King Street Pump Station Improvements (Volume I) & ASR Lime System Improvements (Volume II) - RFCSP
Solicitation Number: CO-00670
Job No.: 20-6002 and 22-8603

ADDENDUM 2
October 12, 2023

2 W. MAYFIELD BLVD. WATER CROSSING PLAN

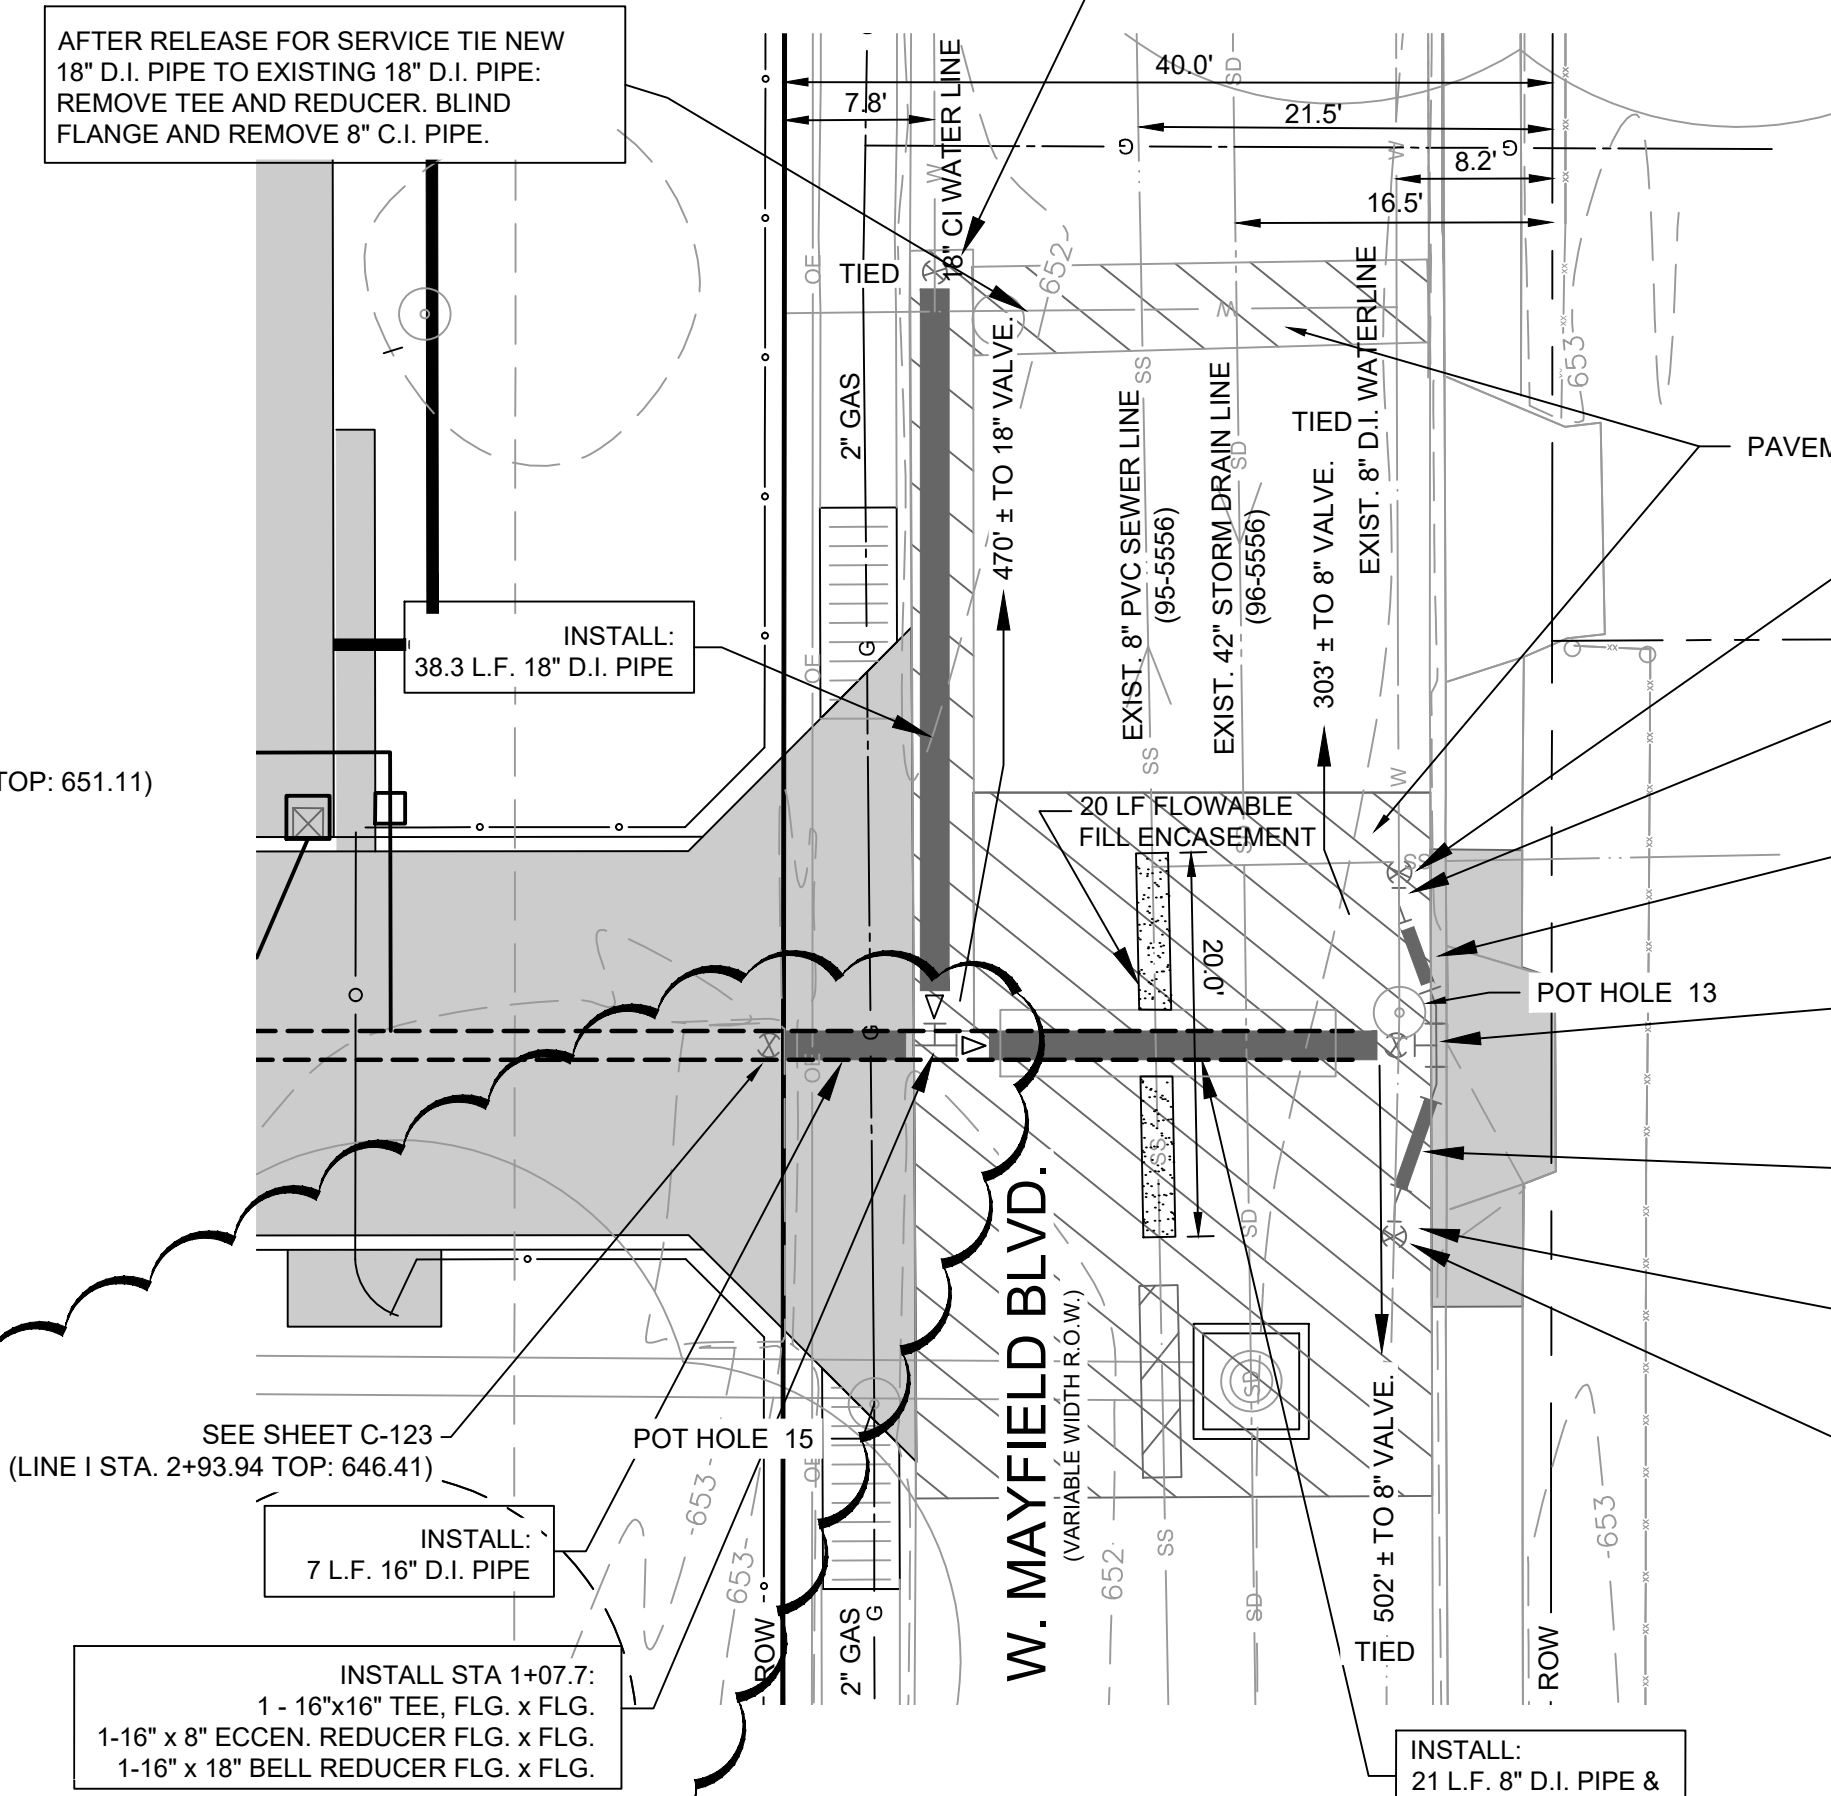
56. Question: Drwg. 25 C114, detail 2. Plan shows 18” DIP. The yard pipe shows 16” DI pipe. Please have engineer clarify.

Response: Refer to “Changes to the Plans” section item No. 1 in this addendum. The 16” piping should extend to the 18” D.I. pipe extension. Plan and profile revised.

D-001

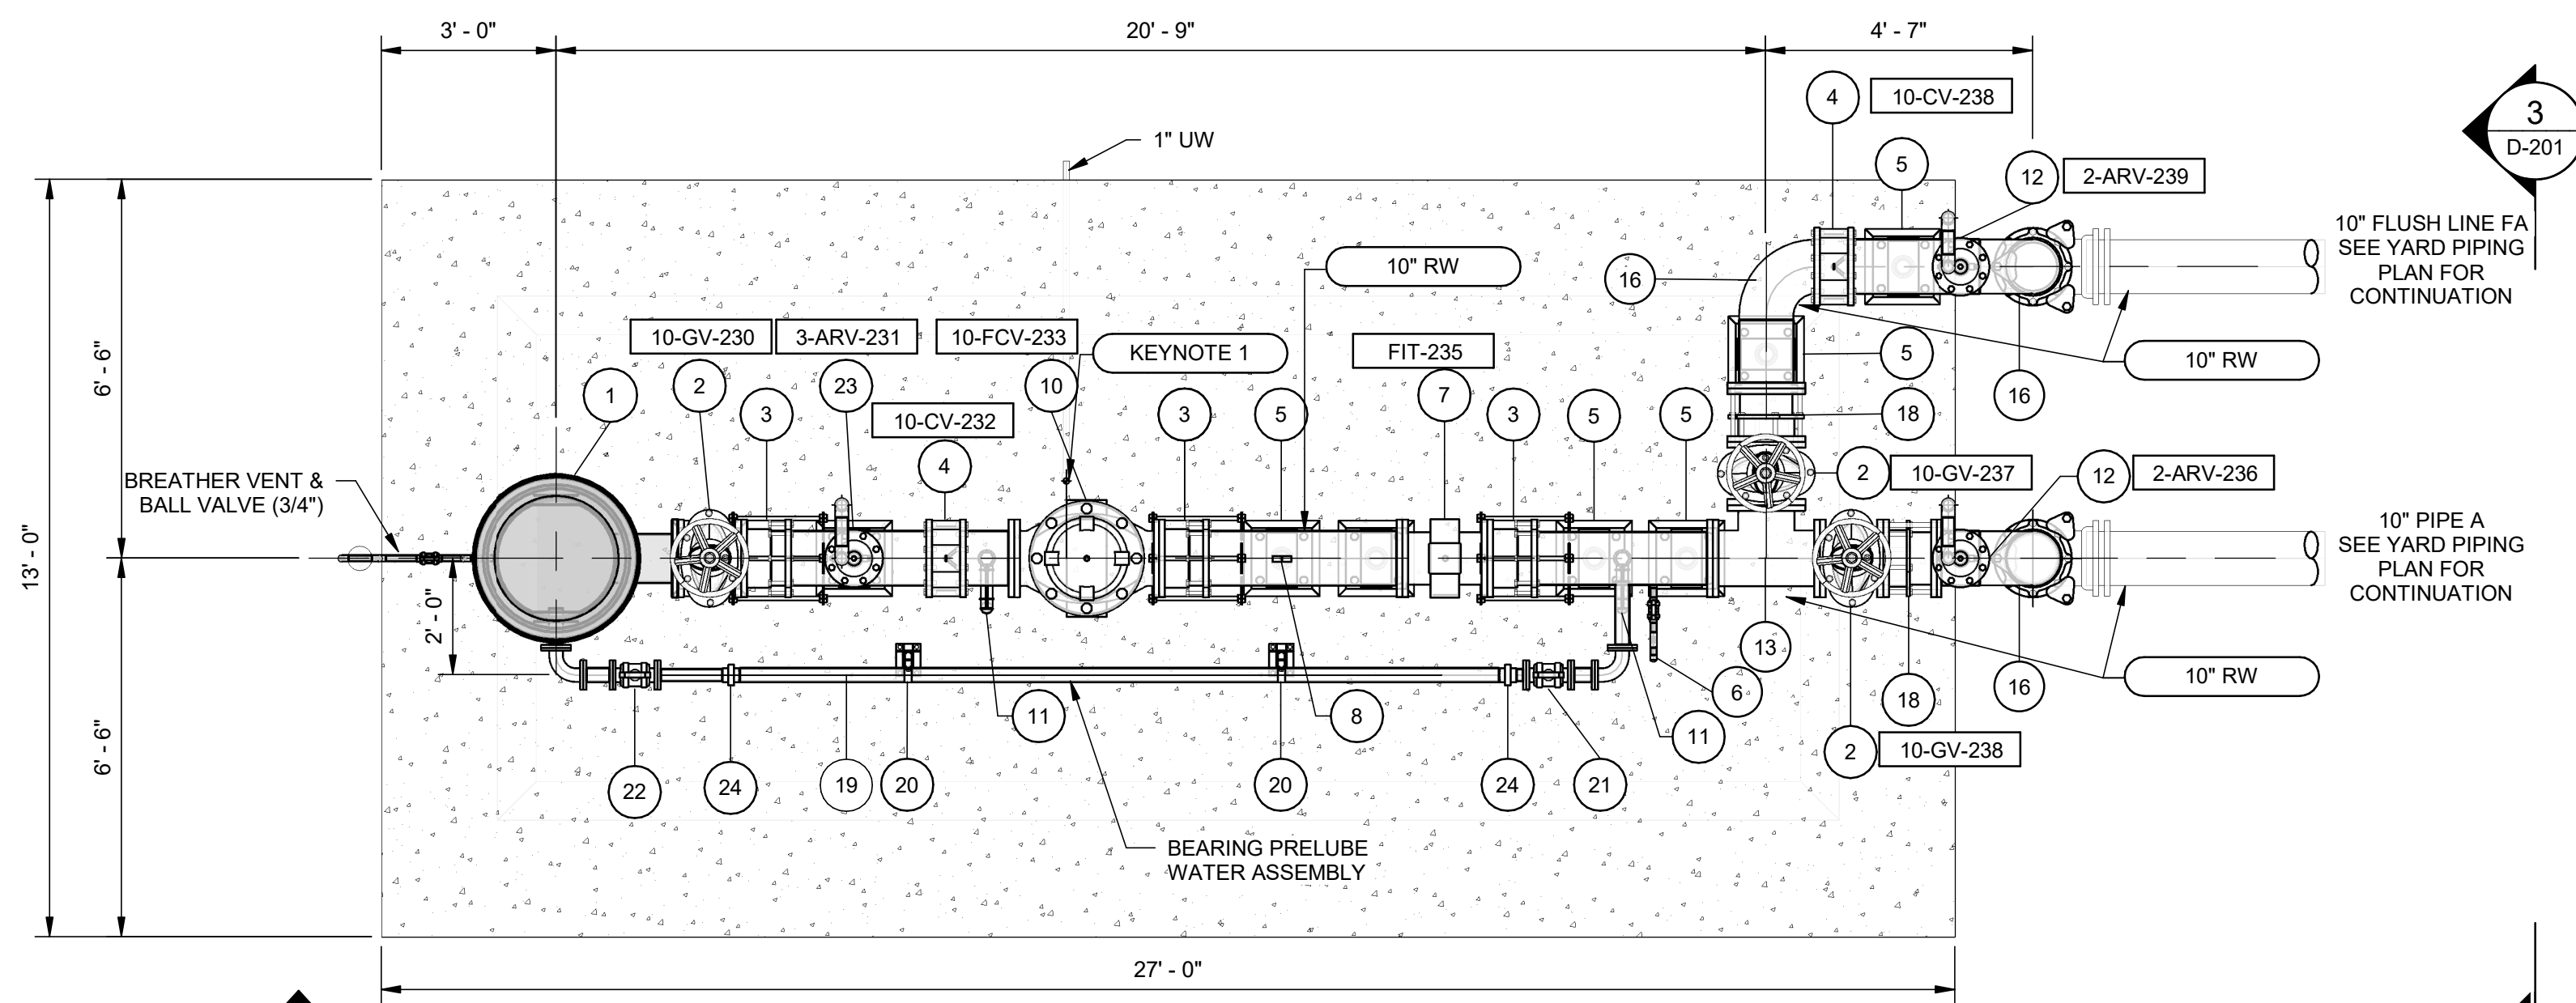
Response: Copies of bid documents are made available in a secured PDF format to identify these documents as official original sealed documents in accordance with regulations promulgated by the Texas Board of Professional Engineers and Land Surveyors. Copies can be made by printing, exporting or other common means for the purpose of marking as needed for estimating as long as these copies are not presented or distributed as original or official documents since they have been subject to alteration by parties other than the Engineer responsible.
- 2. Question: Contract Drawings, Sheet D-305, blowers 3-4-5-6 effluent Air pipe. This Air pipe system is not on the pipe schedule shown on Sheet D-001. Please specify pipe material to be used for this pipe system or if pipe will be supplied with blowers.**

Response: Refer to the "Changes to the Plans" item No. 2 in this addendum. Air pipe system added to schedule on Drawing D-001.
- 3. Question: Specification Section 11110, Paragraph 1.02.E, due to high cost to Witness test compared to size of equipment, Witness testing is not recommended. Please remove Witness test requirement for the HSC units in this specification. Not generally recommended on equipment this size.**
